I think the Odana Rd & S Whitney Way HSIP leaves much to be improved. I urge you to provide strong feedback specifically to remove one of the unnecessary Eastbound receiving lanes, replacing with a bike lane. Please see my below illustration.

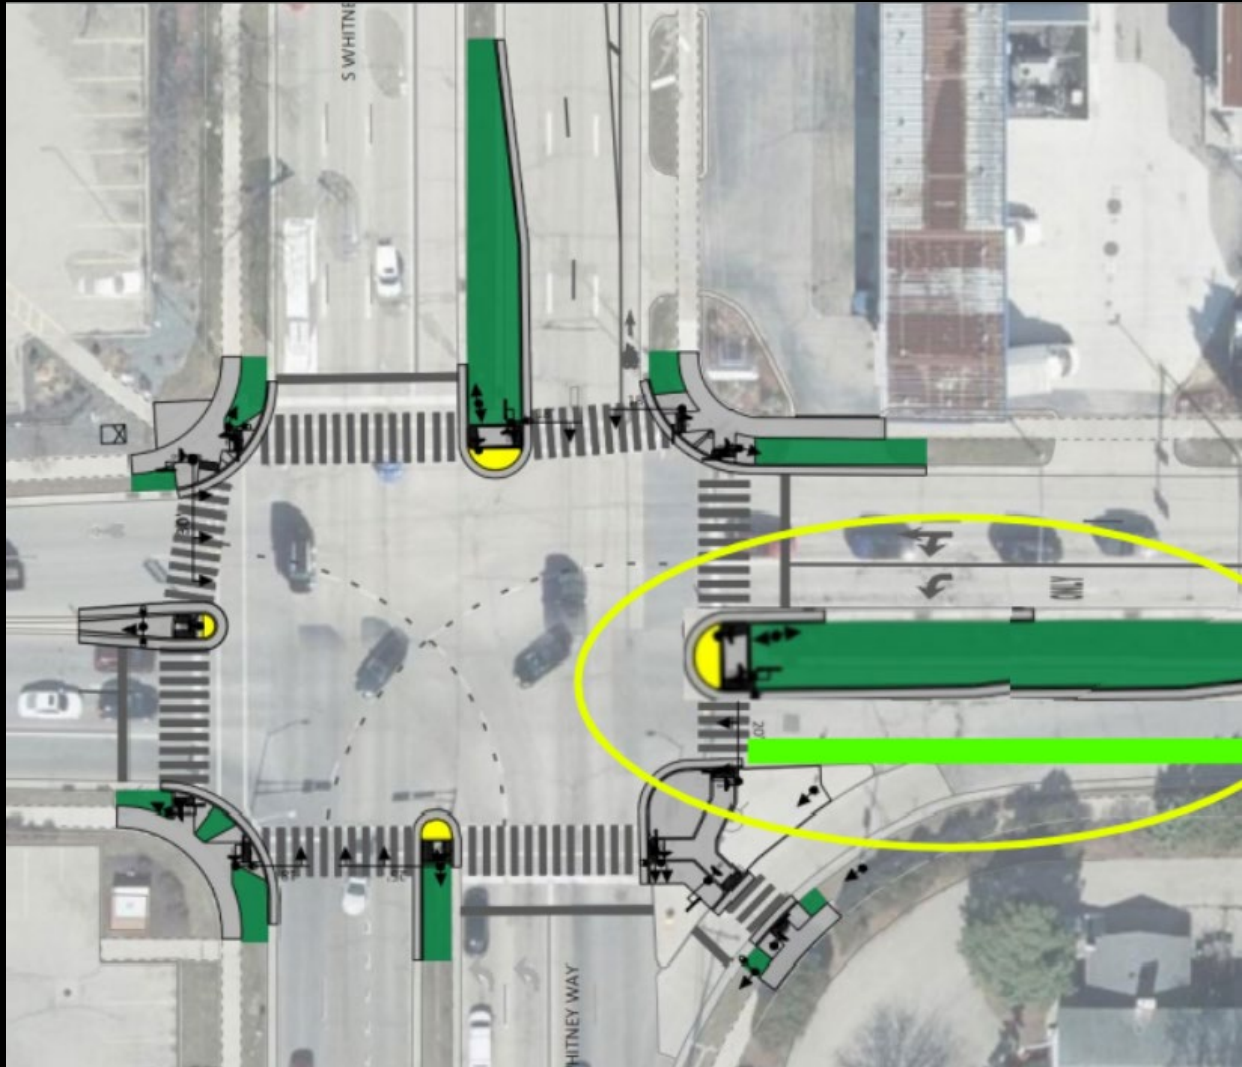
This should be a required change to this proposal. I think we could do much better though.
